## STAFF REPORT SUMMARY

To: Edgerton Planning Commission  
Fr: Kenneth Cook, AICP, CFM, Community Development Director  
Re: FP2017-01 for Final Plat for Inland Port XL, located West of Waverly Road and South of 181<sup>st</sup> Street.

To: Edgerton Planning Commission  
Fr: Kenneth Cook, AICP, CFM, Community Development Director  
Re: FP2017-01 Final Plat for Logistics Park Kansas City Rail Served-First Plat

To: Edgerton Planning Commission  
 Fr: Kenneth Cook, AICP, CFM, Community Development Director  
 Re: Application FS2017-01 for Final Site Plan for Inland Port XXI, located South of 191<sup>st</sup> Street and East of Four Corners Road.

Inland Port XXI  
Final Development Plan  
Logistics Park Kansas City - Southeast, Fourth Plat, Lot 1

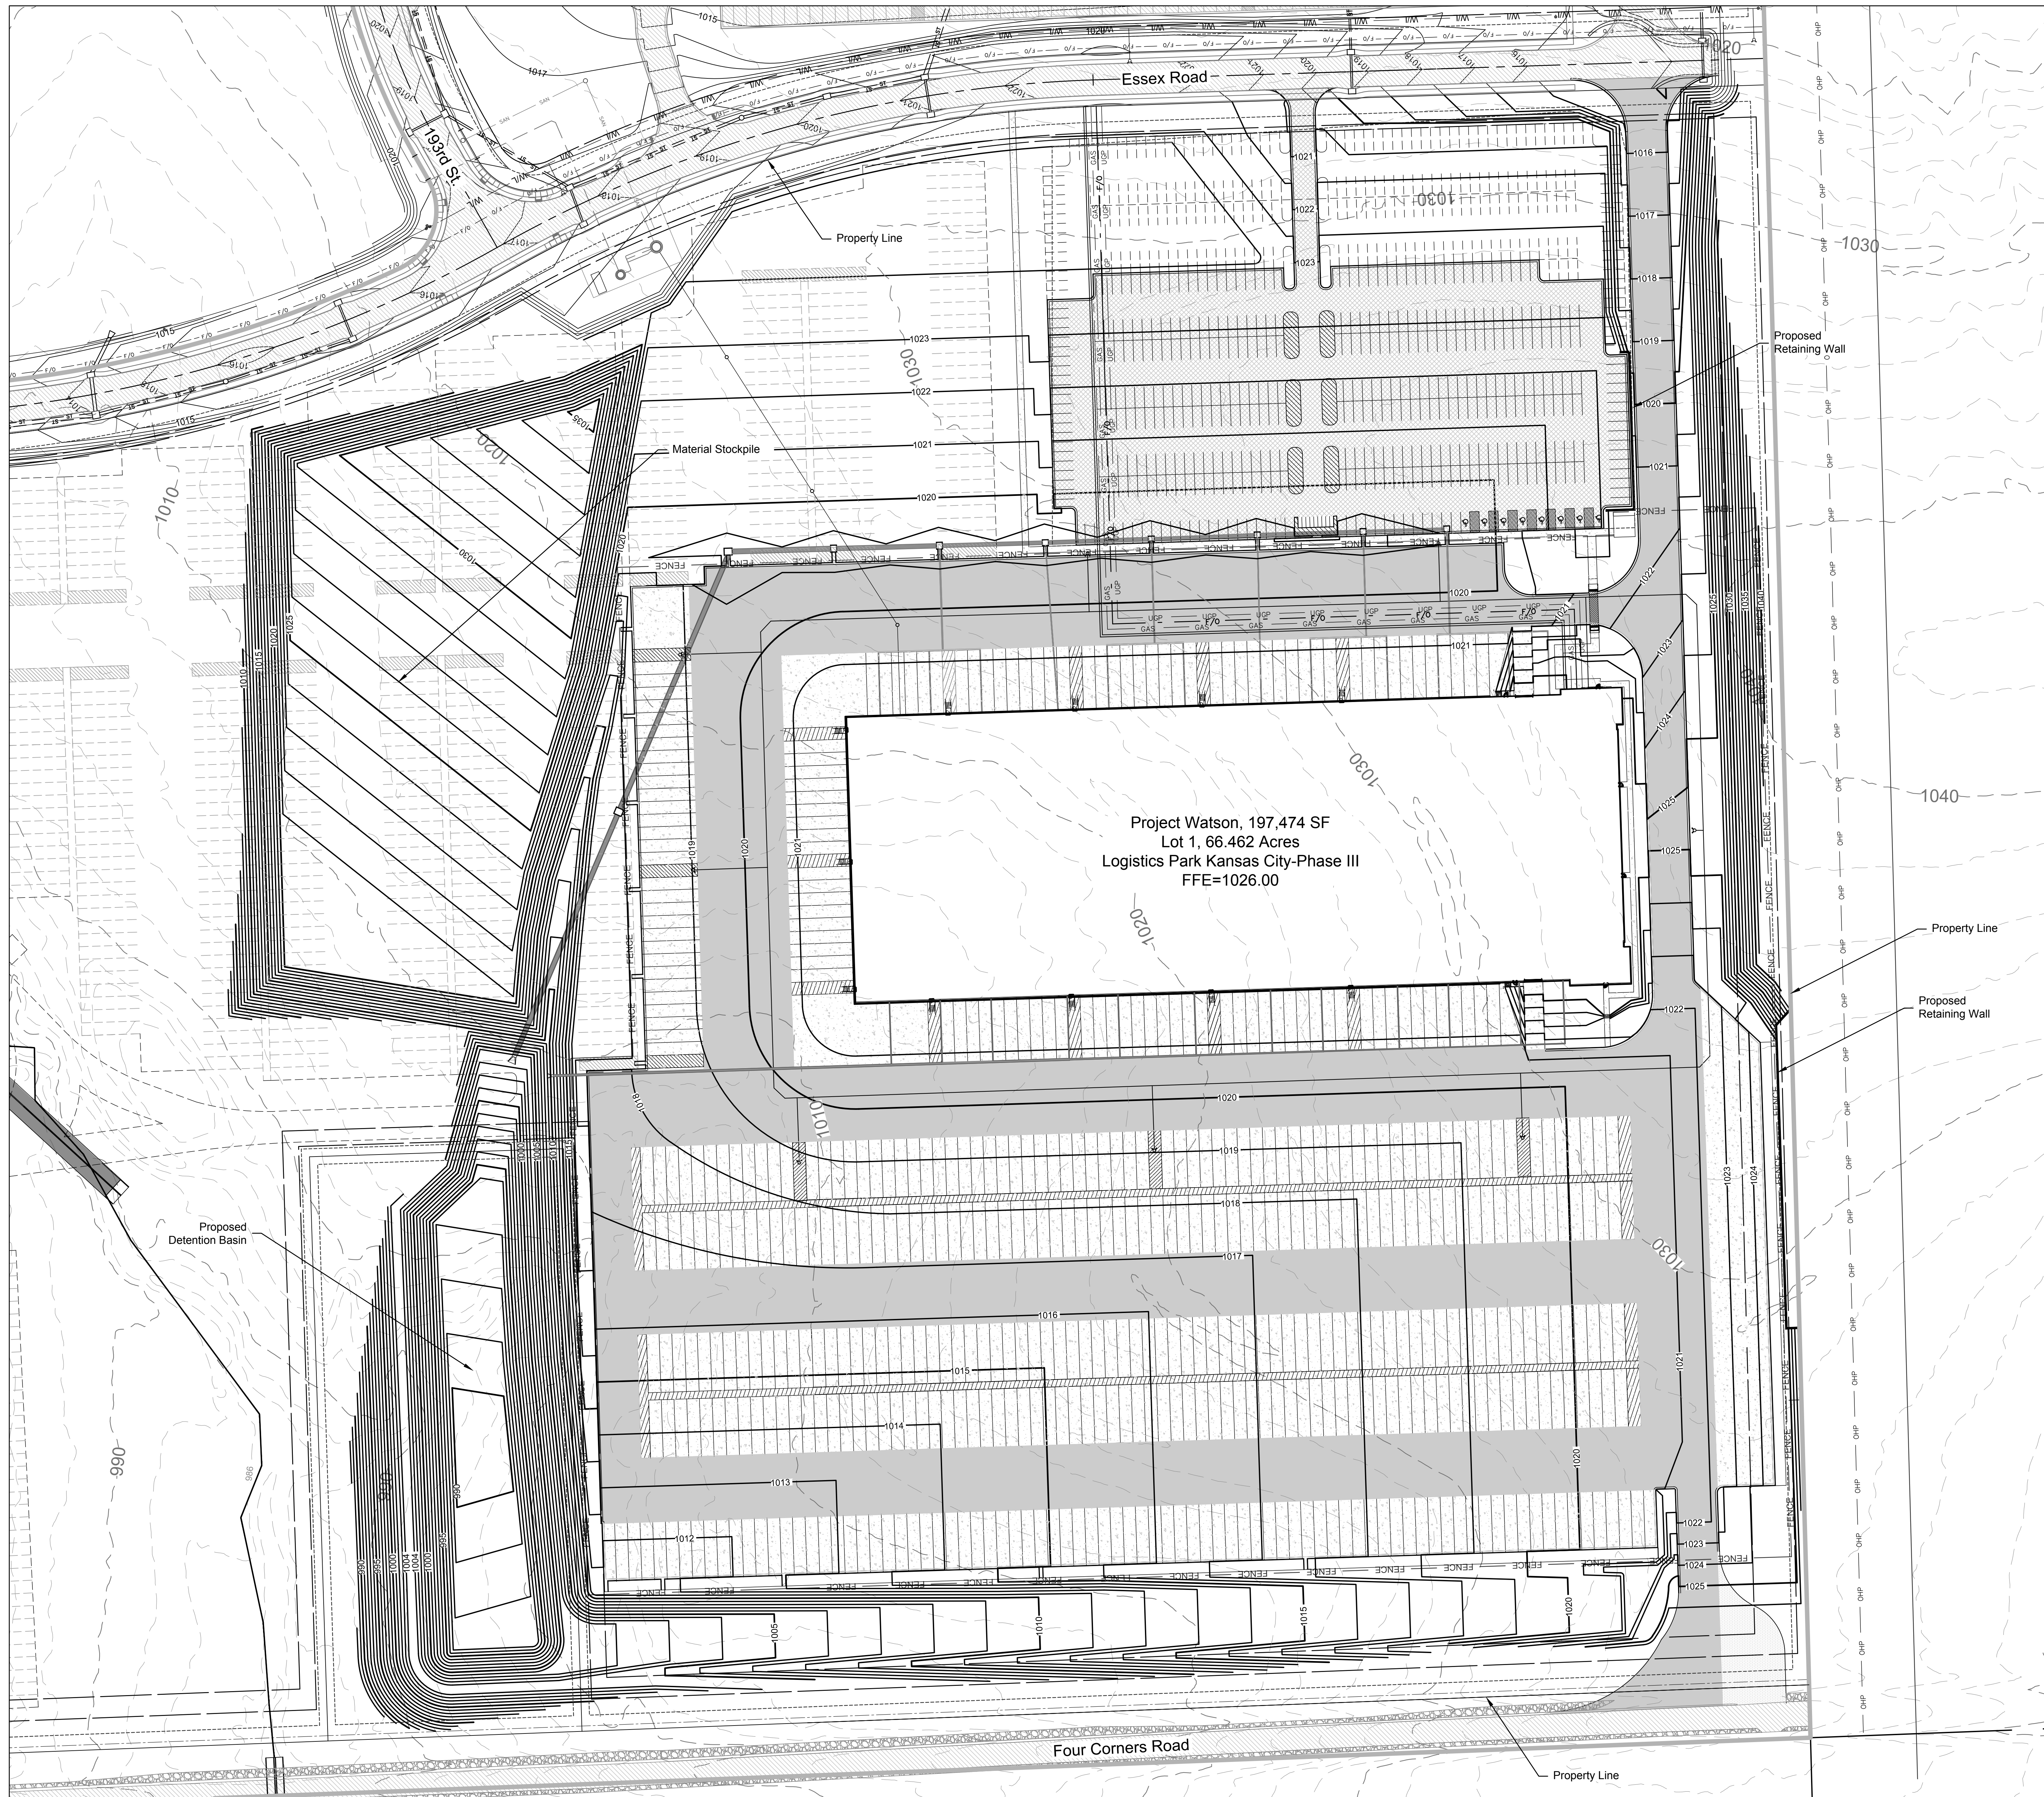
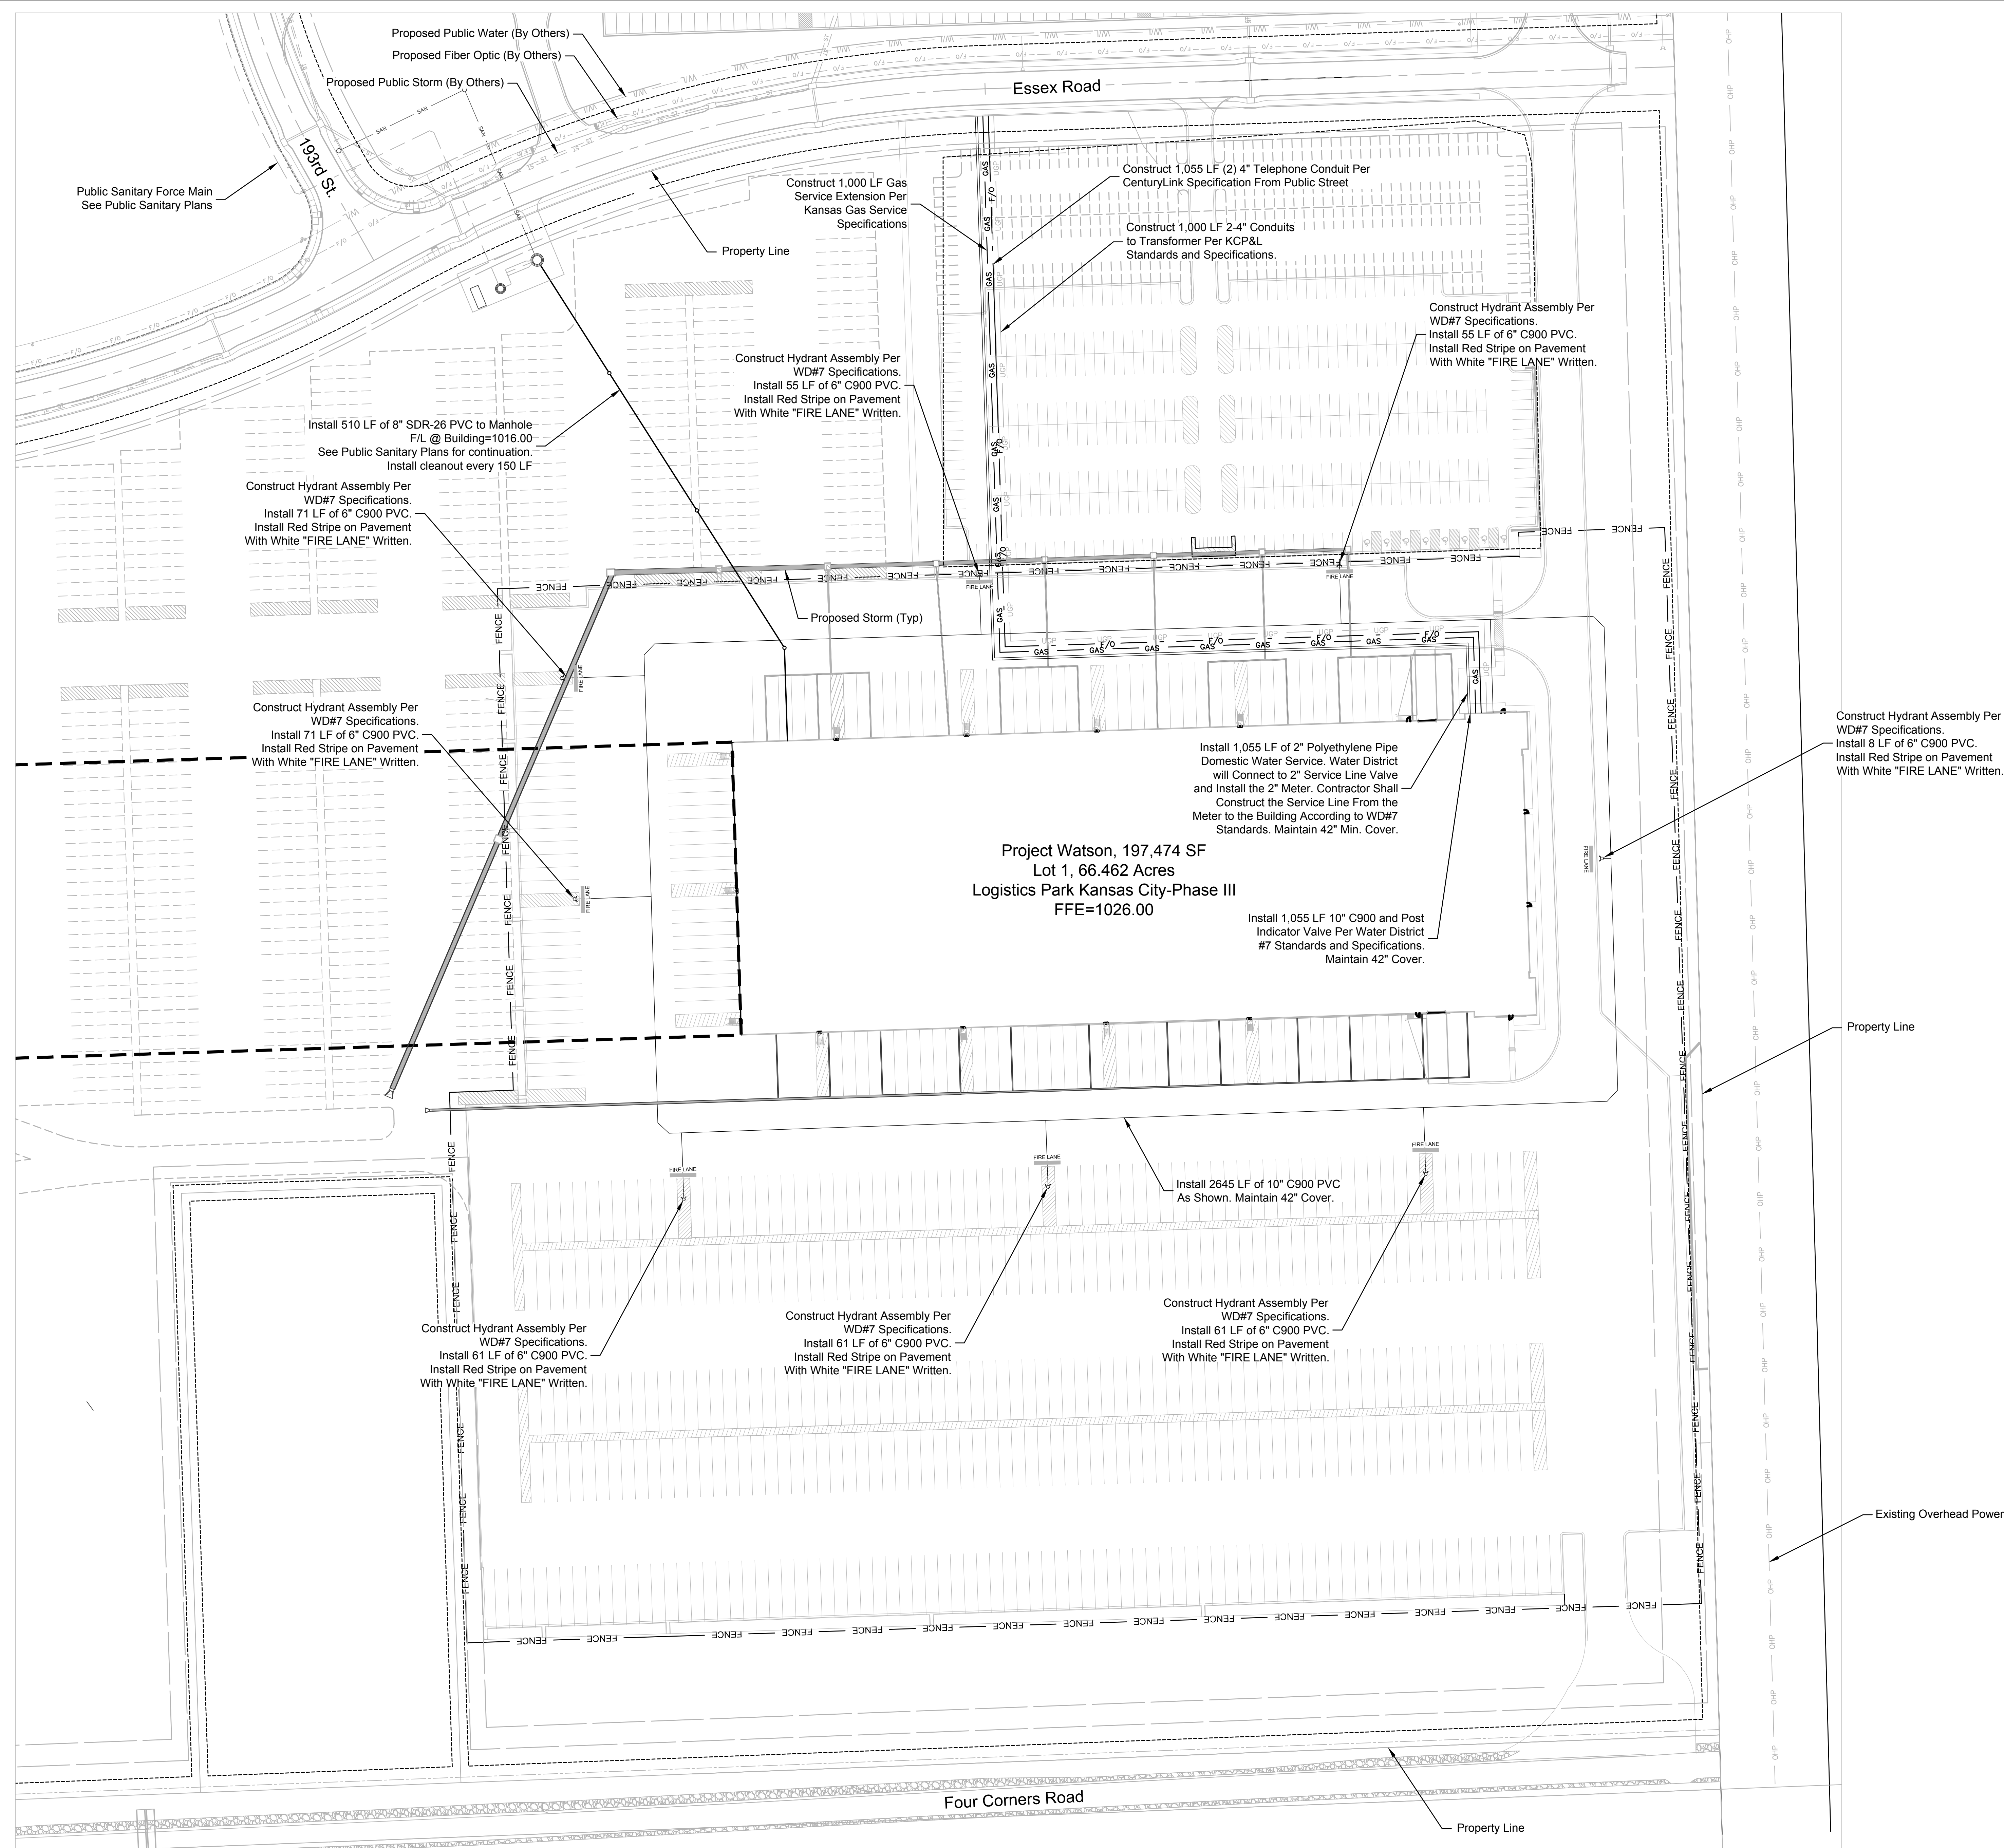
1. Front or cover sheet.
  - a) A scale vicinity map showing the relationship of the site to surrounding neighborhoods, roads and other physical features. *Show the alignments for Essex and 193<sup>rd</sup> Streets. Update Final Site Plan.*

- b) A project title, zoning designation and project sponsor. A street, lot or tract address of the project. *The existing title is incorrect and needs to be updated to specify Logistics Park Kansas City Phase III, First Plat, Lot 1. Update the address included in the title to 19400 Essex Street. Update Final Site Plan.*

- a) A site map with the following features.
  - i) Topography at reasonable intervals. *What is the slope of the detention basins. Riprap or other erosion prevention should be placed at the outlet of pipes and flumes and in the southwest corner of the detention basin where the concentrated flow runs over the steep side slopes. The detention pond outlet pipe has not been shown. Update Final Site Plan.*

- iv) Parking areas, paths, walks with sizes and surfaces material specifications. *Update Final Site Plan.*
    - a) *The surface material specifications for the future parking areas are not shown. At least a note should be included on the plans specifying that the future areas would be paved in the same manner as the first phase.*

- b) *The crosshatching for existing pavement is partially incorrect as Essex and 193<sup>rd</sup> Streets are also shown as existing pavement.*
  - v) Exterior lighting specifications. *No photometric plan has been provided. Update Final Site Plan.*

- vi) Site entrance and connections to streets. *The Southeastern entrance width exceeds the 30' maximum width allowed. Update Final Site Plan.*
  - vii) The location of easements. *The proposed detention basin and public drainage flow should be located in a drainage easement. Update Final Site Plan.*

- viii) Connection point for utilities. *Update Final Site Plan.*
    - a) *The Service line from the building should connect to the gravity main as a tap and not a direct connection to the wetwell. Public sanitary sewer line may be necessary depending upon the alignment.*

- b) *Public improvement plans for the proposed sanitary sewer line are required. The plans should be submitted to the City for review and once all comments have been addressed the City will submit them to KDHE for approval.*
